#### COMMENTS

Appl. No. : 09/938,428  
Filed : August 23, 2001

Figure 1B

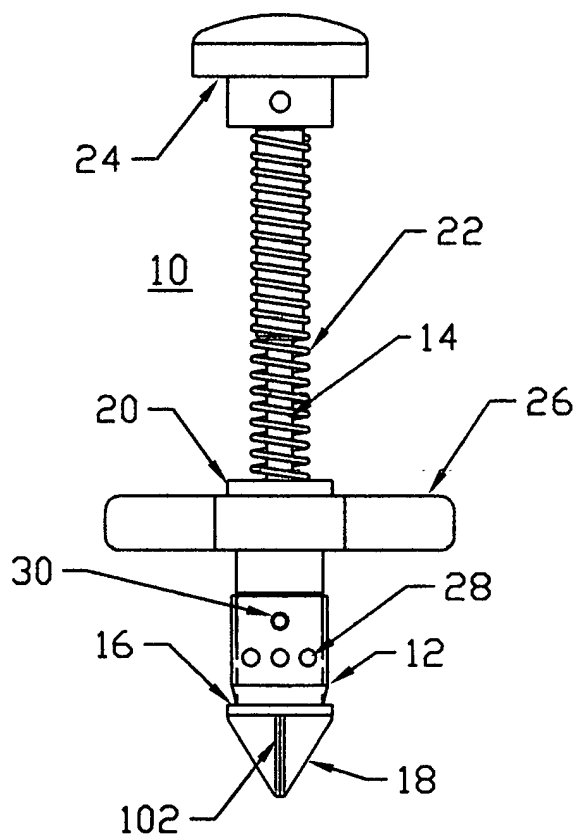
Figure 1B now depicts longitudinal ridges or edges **102** on the tapered tip. The longitudinal ridges **102** are supported in the originally filed specification. On page 12, lines 16 and 17, the specification states, "Longitudinal edges are optionally disposed on the conical surface of trocar or tip **18** to enhance tissue penetration". In addition, Claims 9, 10, and 11 of the originally filed application, state:

Accordingly, Applicants respectfully submit that no new matter is introduced by the proposed drawing change to Figure 1B.
